**In re: The Narragansett Electric Company d/b/a National Grid ("TNEC")
Notice of Intent to Construct a Loop Line of Less Than 1,000 Feet (Chase Hill Substation
Loop Line)**

**ENERGY FACILITY SITING BOARD'S
FIRST SET OF DATA REQUESTS TO
NATIONAL GRID**

ENERGY FACILITY SITING BOARD'S
SECOND SET OF DATA REQUESTS TO
NATIONAL GRID

EXHIBIT D
CHASE HILL TRANSMISSION LOOP
138 Ashaway Road
Hopkinton, Rhode Island
May 11, 2015

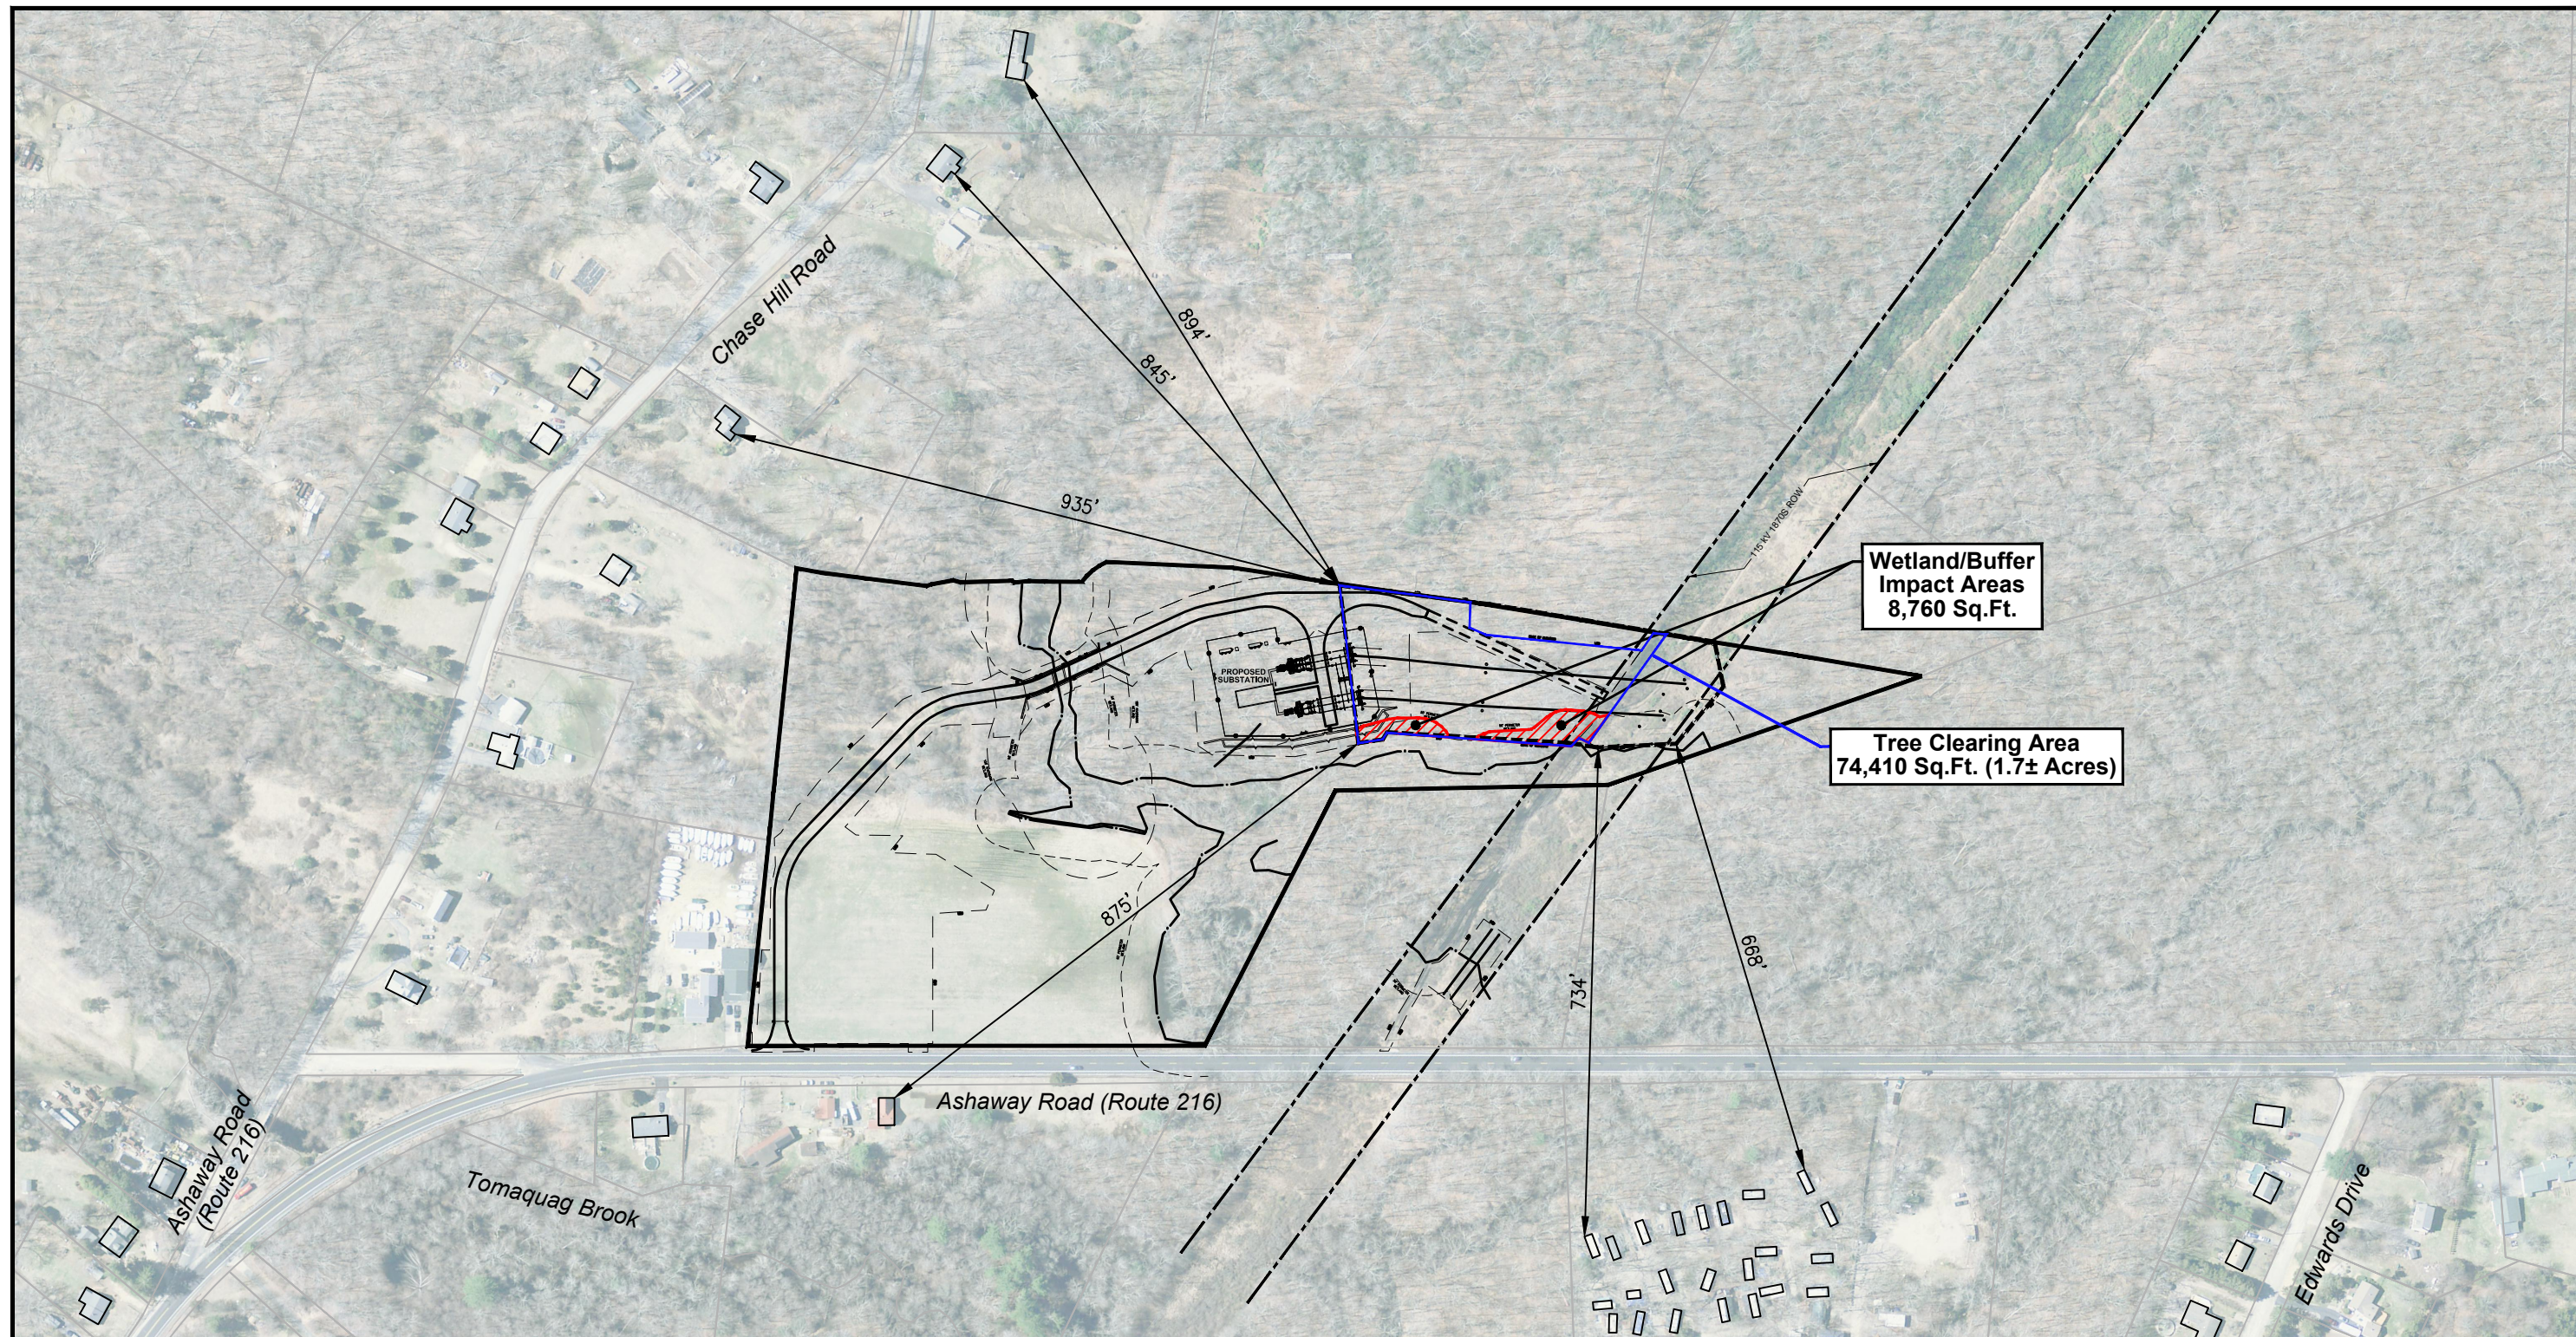
DATA REQUEST NO. 1-3: Please identify how close this construction will occur to a residential area.

RESPONSE: As shown on the map attached as Exhibit D, construction activity for the Loop Line will occur as close as 668 feet from a residential abutter on Ashaway Road and 845 feet from a residence on Chase Hill Road. Residences along Chase Hill Road range from 845 feet to greater than 1,000 feet from the limit of clearing/disturbance for the Loop Line.
